Project	IEEE 802.16 Broadband Wireless Access Working Group < http://ieee802.org/16 >	
Title	Changes on Sleep-mode SDL	
Date Submitted	2004-03-05	
Source(s)	Changjae Lee, Kiseon Ryu, Jay Jin LG Electronics, Inc. 533, Hogue-1dong, Dongan-gu, Anyang-shi, Kyongki-do, Korea	Voice: 82-31-450-4387 Fax: 82-31-450-7912 [mailto:cjlee16@lge.com]
Re:	This is a response to a Call for Comments IEEE802.16e-04/xx on IEEE P802.16e-D1	
Abstract	This document contains suggestions to change the SDL on Sleep mode operation.	
Purpose	This document is submitted for review by 802.16e Working Group members	
Notice	This document has been prepared to assist IEEE 802.16. It is offered as a basis for discussion and is not binding on the contributing individual(s) or organization(s). The material in this document is subject to change in form and content after further study. The contributor(s) reserve(s) the right to add, amend or withdraw material contained herein.

Changes on Sleep mode SDL

Figure 108d—Typical MSS Listening SDL Diagram

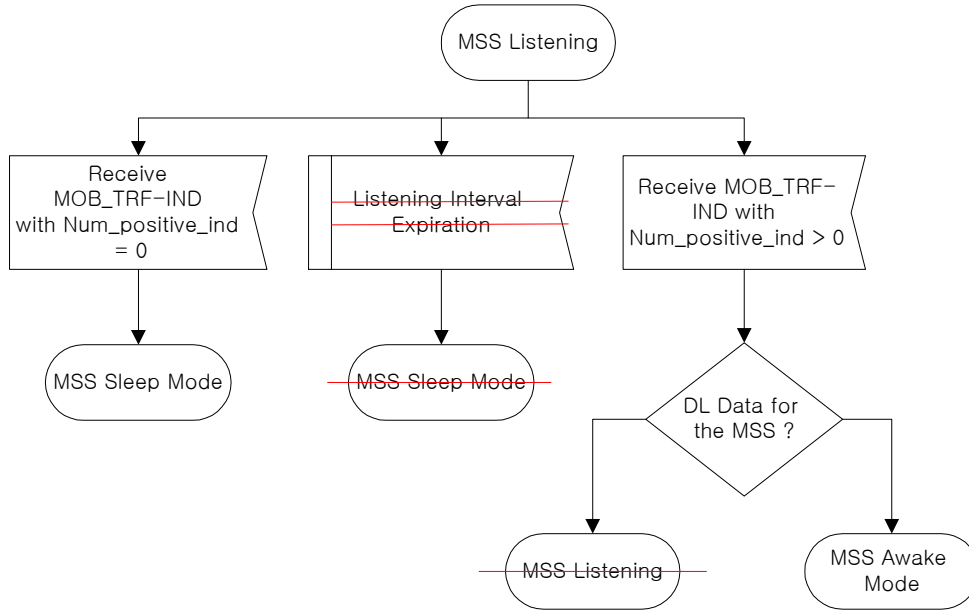
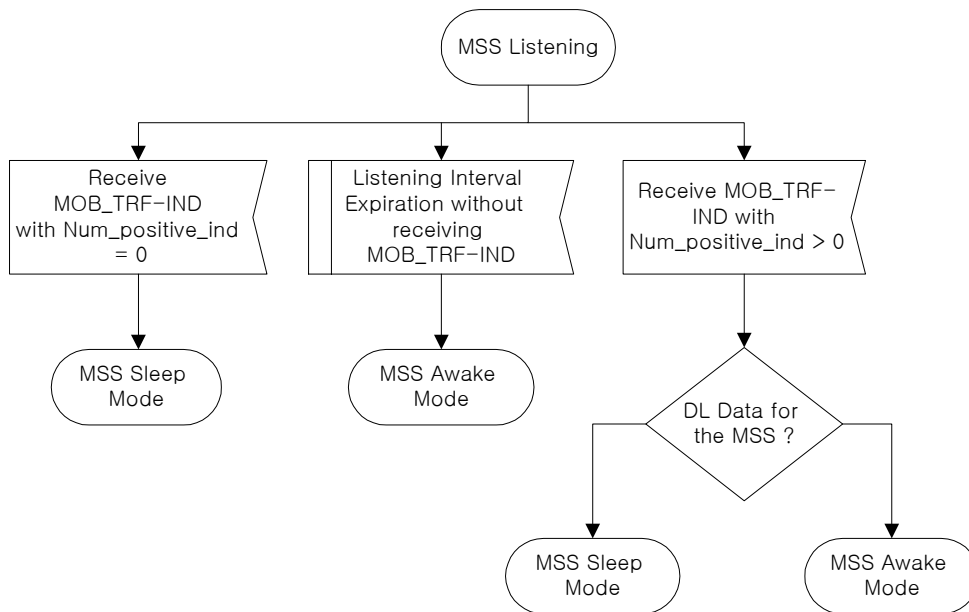
But, the Figure 108d at page 39 shows something wrong as follows.

- MSS returns to Listening mode in spite of the case of 2).
- There is no description about the case of 4) in the figure.

So, we propose changes on Sleep mode SDL in the Figure 108d at page 39.

[Replace Figure 108d to the following:]

In the case of 1) and 2), the MSS shall return to Sleep mode.

In the case of 3), the MSS shall remain awake, terminating the sleep-interval and re-entering Normal Operation.

So, in the case of 4), the MSS shall return to Normal Operation.
